Product Change Notice (PCN)

PCN Number: **PCN-0450914R-01**

Product(s) Affected: MJ1-2510-SMT-TR

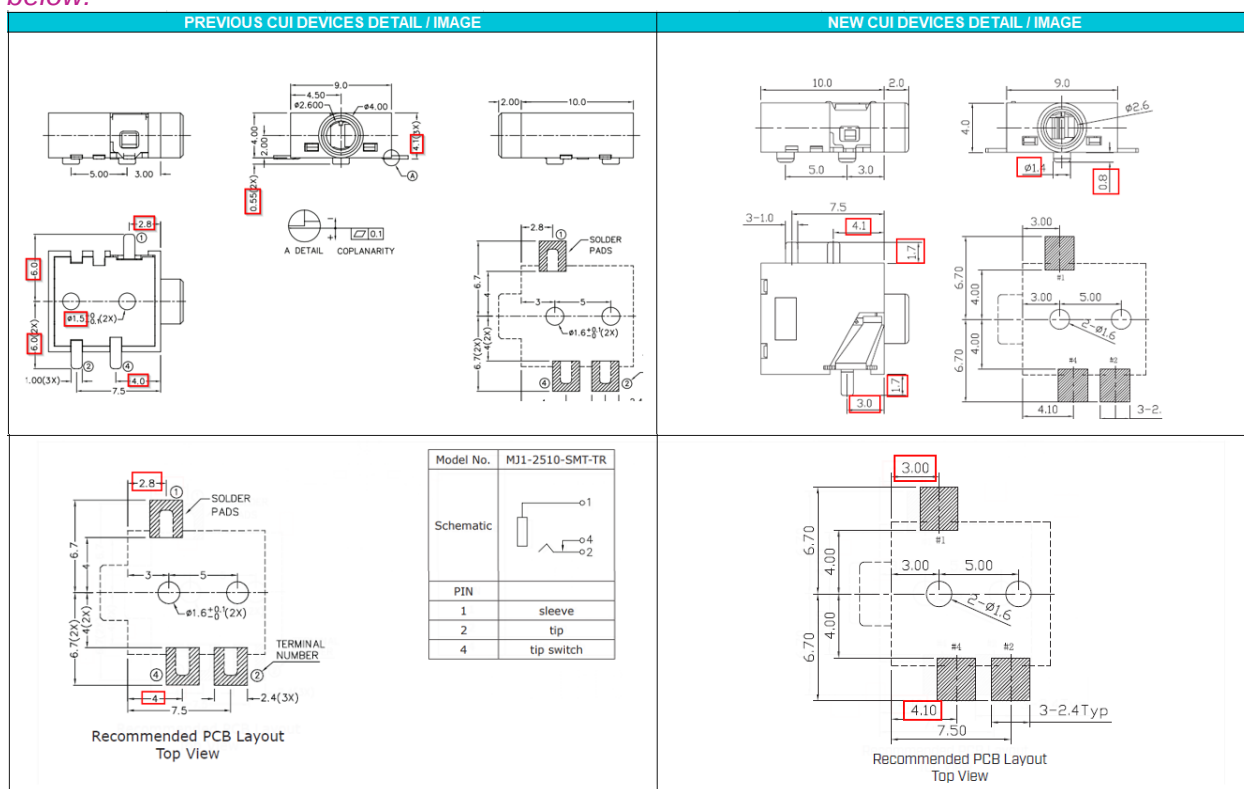
Description of Change: *Mechanical, material, soldering, and packaging changes as shown below:*

MATERIAL	PLATING
terminal 1	copper alloy	gold flash
terminal 2	copper alloy	gold flash
terminal 4	brass	gold flash
plastic	PA6T or equivalent

DESCRIPTION	MATERIAL	PLATING/COLOR
terminal 1	copper alloy	gold over nickel
terminal 2	copper alloy	gold over nickel
terminal 4	copper alloy	gold over nickel
housing	PPA [UL94V-0]	black
cover	PPA [UL94V-0]	black

parameter	conditions/description	min	typ	max	units
reel storage	at relative humidity <80%		40		°C
reflow soldering ¹	see reflow profile	255	260	265	°C
drying conditions ²	parts in reel: bake at 40°C ±5°C for 72 hours parts removed from reel: bake at 40°C ±5°C for 10 hours

parameter	conditions/description	min	typ	max	units
reel storage	5-25°C, 20-75% humidity				°C
reflow soldering	see reflow profile	255	260	265	°C

Note: 1. CU Devices recommends usage of the product within 24 hours after TSM is opened. After 24 hours, CU Devices recommends drying the parts prior to use.
